CITY OF BEAUFORT - HISTORIC DISTRICT REVIEW BOARD

Wednesday, August 12, 2026, 2:00 P.M.

**B. 1010 Boundary Street/1112 Charles Street, PIN: R120 004 000 0071-/0072-/0073 0000:
Construction of eight (8) new townhomes (two 4-unit buildings) & four (4) duplexes (two 2-unit buildings; infill development)**

**Conceptual Plans (July 2026) with
comments from Meadors Architecture**

1010 Boundary Street – Overview of main changes

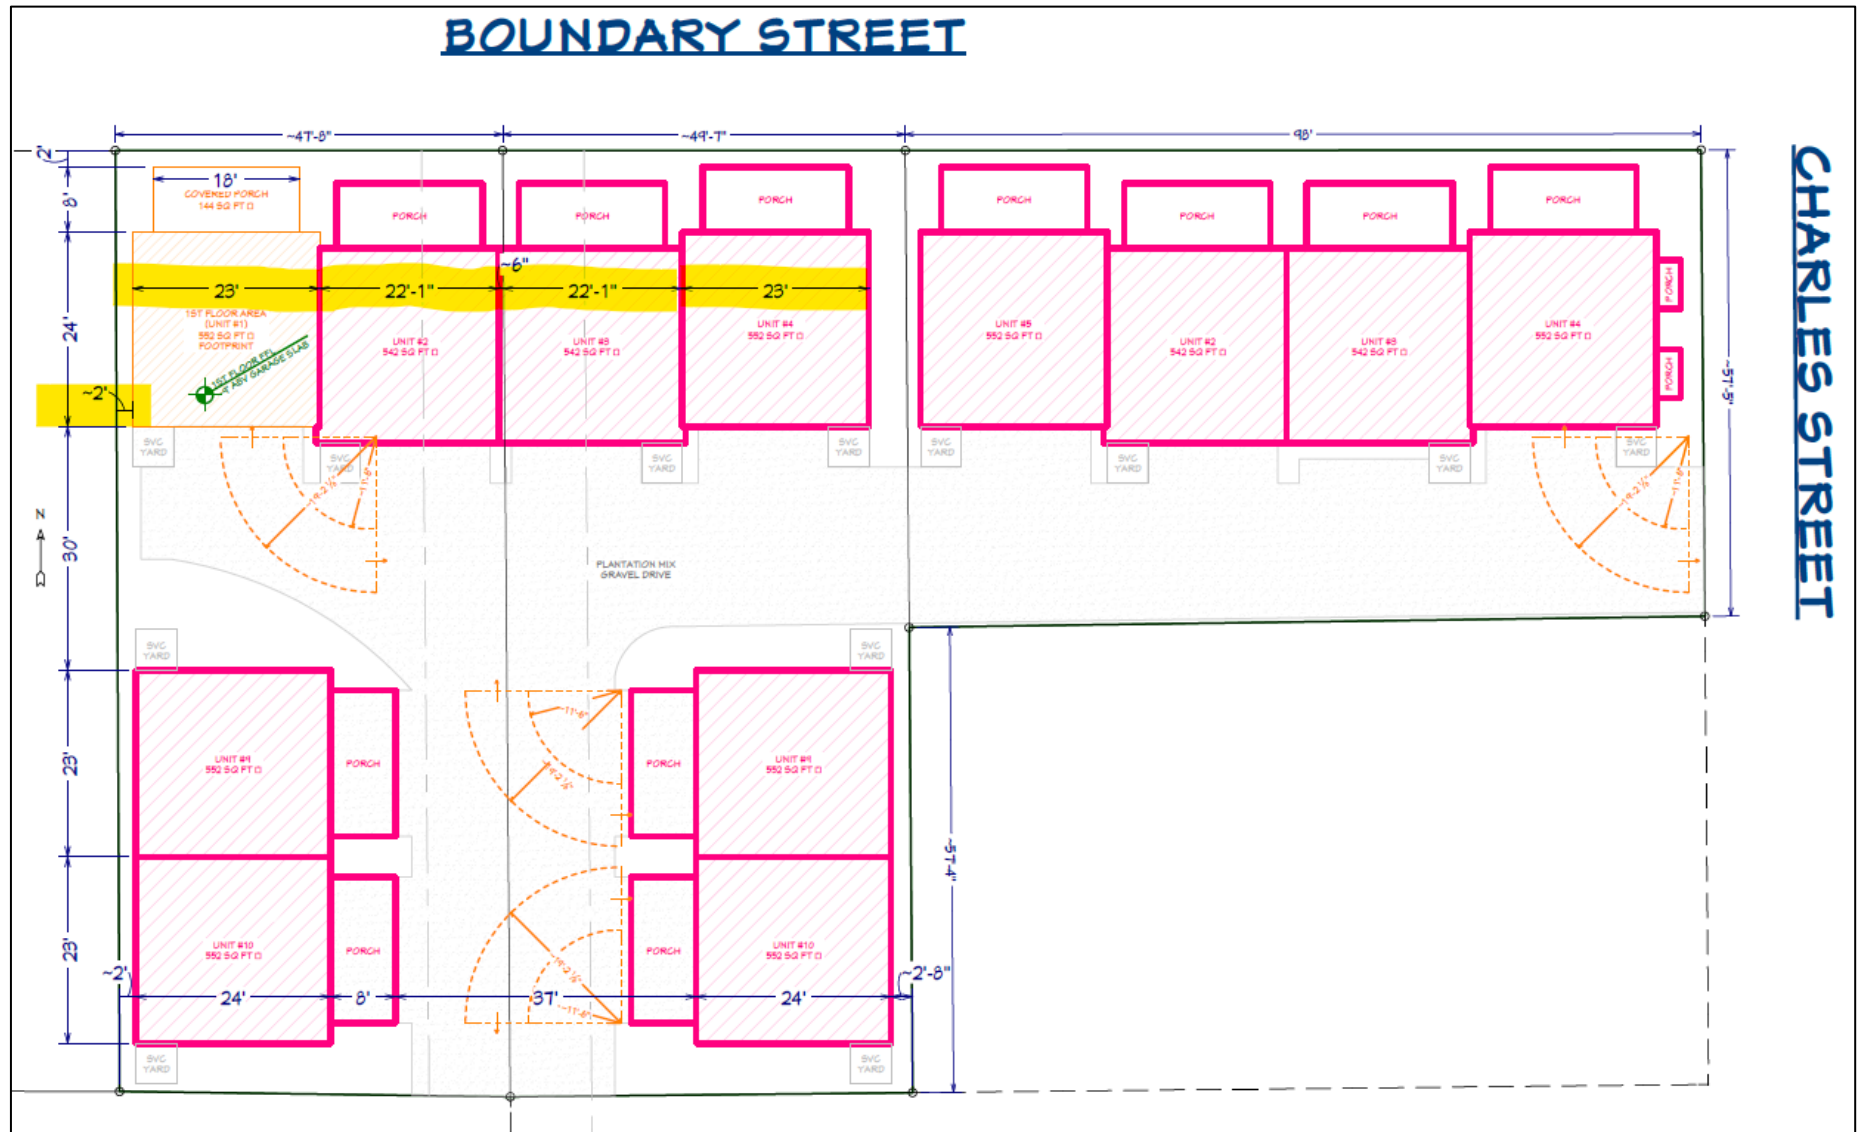
- The latest design revisions include an overall reduction of the width of the two (2) Townhouse buildings (4 units per) along Boundary Street from the previous 97ft. 3in. to now 90ft. 11in.
- The latest change includes an increased setback to the adjacent property to the west ("Alpha Graphics") from formerly 2ft. to now 5ft. 9in.
- Also, there is a 6ft. separation between the two Townhouse buildings in the middle and a 2ft. setback from Charles St. on the east.
- Whereas the front Townhouses are served with ground-level 2-car garages in the rear, accessible through an Access Easement that connects with Charles Street on the east and Newcastle Street to the south and west, the rear 4 duplexes will have side-loading garages.

- After the last HDRB (6-10) and HTRC (7-15) Meetings, the overall building design has been revised as per the following:
 - Grand staircases leading up to the main entrances of the Boundary Street-facing townhomes have been added to reflect similar concepts as seen for example in historic downtown Savannah, GA.

- Previous balconies and dormers (non-usable) have been removed
 - Street-facing main gables roofs have been replaced with a flat roof concept for the middle townhome units and lower-pitched side facing gabled-roof lines on the sides (also roof cornices and eaves added at front elevation)

- Front entrance porticos (some shared) as well as bay windows for the Charles St. townhouse unit have been added for a more holistic and street-corner embracing façade that appears both functional and architecturally less busy

- Renderings of duplexes now have been included, which show a similar building design to the townhouses, except for side-bearing garage entrances (rather than rear)

BOUNDARY STREET ELEVATION
SCALE 1/4" = 1' - 0"

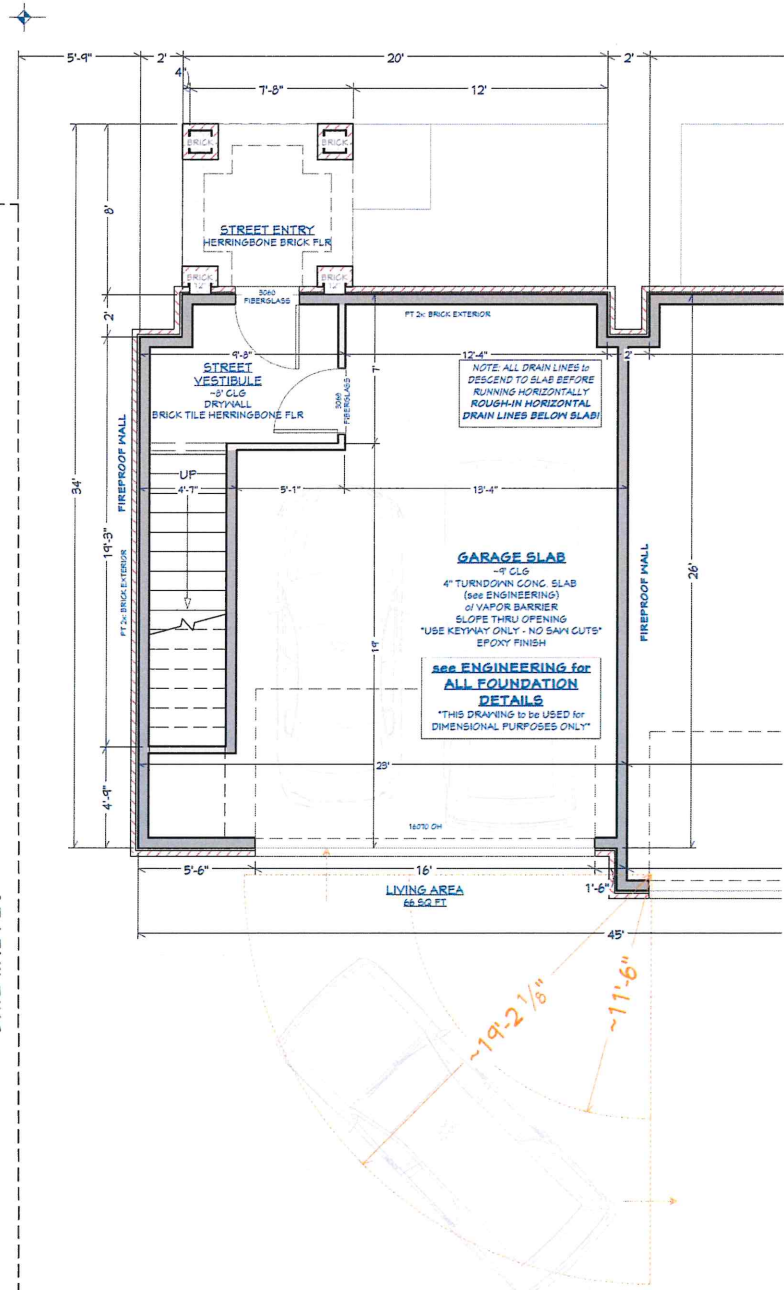
1. Bay windows: Staff could be supportive of a bay window on the Charles Street side but has concerns about the detailing and placement. Staff recommends raising the top of the bay window so that its cornice matches that of the main structure, as well as matching the design of the main structure's cornice. Staff also recommends revising the blank panels above and below the bay windows to provide more detail.

2. Masonry base: Staff has concerns about the brick ledge at the top of the brick veneer and has concerns that this is a "suburban" detail. To appear as a traditional masonry base, the veneer should either be thin brick, or the floor framing should be cantilevered to allow the siding and brick face to be aligned on the same plane.

CROSS SECTION
SCALE 1/4" = 1' - 0"

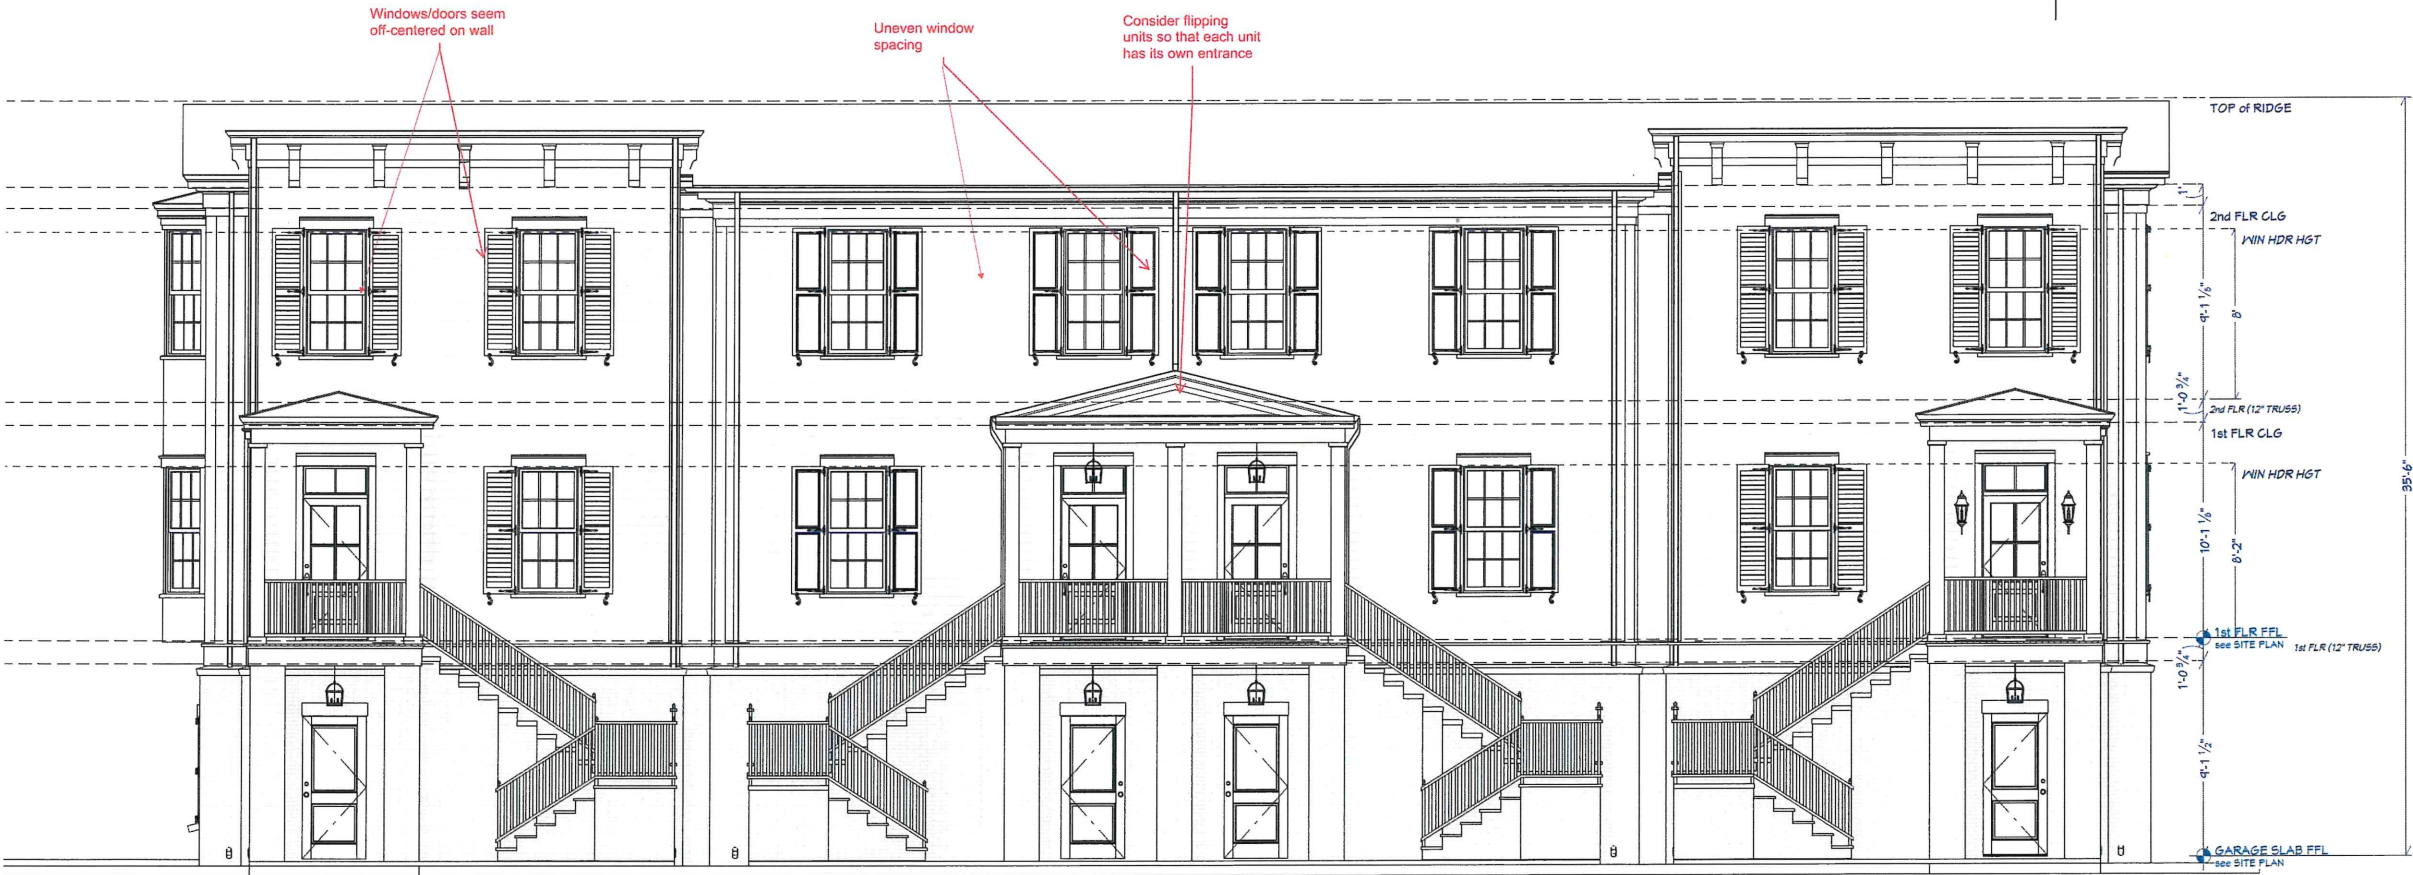
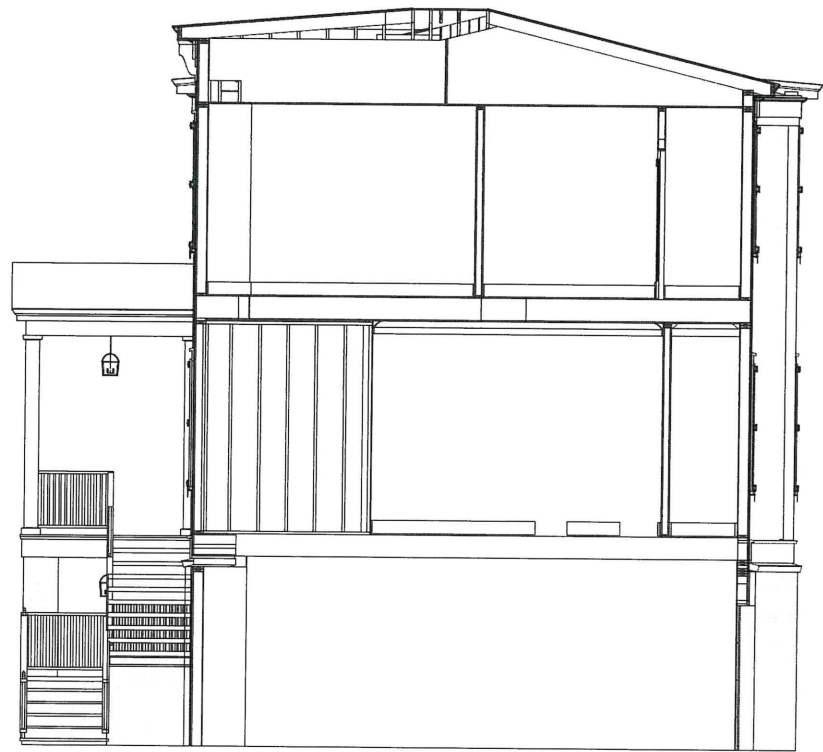
See additional comments on page 3

PRINT SHOP SIDE ELEVATION
SCALE 1/4" = 1' - 0"

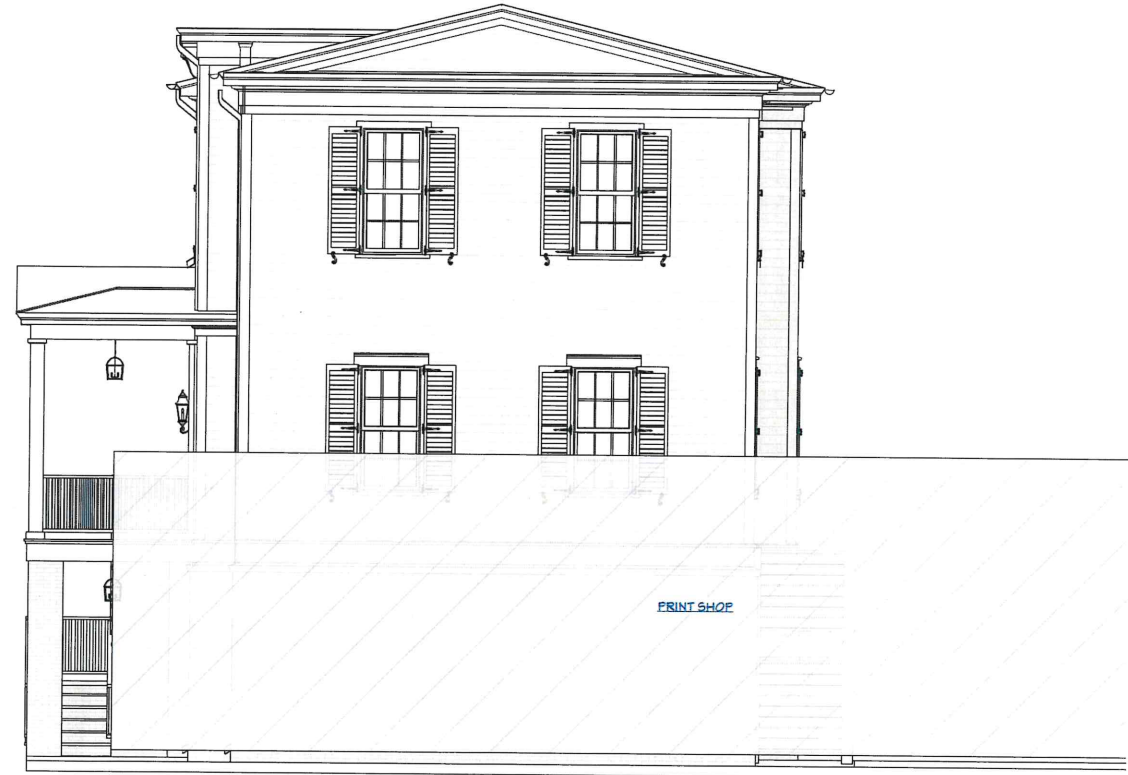
- **Planning and Zoning:**
 - Any/all shutters are required to be operable.
 - Proximity to the printing building might be a problem – need to analyze distance from the building, figure out how to obtain at least 5 ft separation. Faux windows are not permitted. Fire-rated windows would be acceptable. Staff recommends shortening the buildings to reach the 5 ft separation.

- Any/all shutters are required to be operable.
- *Proximity to the printing building ["Alpha Graphics"] might be a problem – need to analyze distance from the building, figure out how to obtain at least 5 ft separation. Faux windows are not permitted. Fire-rated windows would be acceptable. Staff recommends shortening the buildings to reach the 5 ft separation.*

Applicant's Next Steps: For August HRB meeting, make revisions discussed in this meeting, provide duplex elevations and details, stairway revisions, resolved issue with separation for the printing building
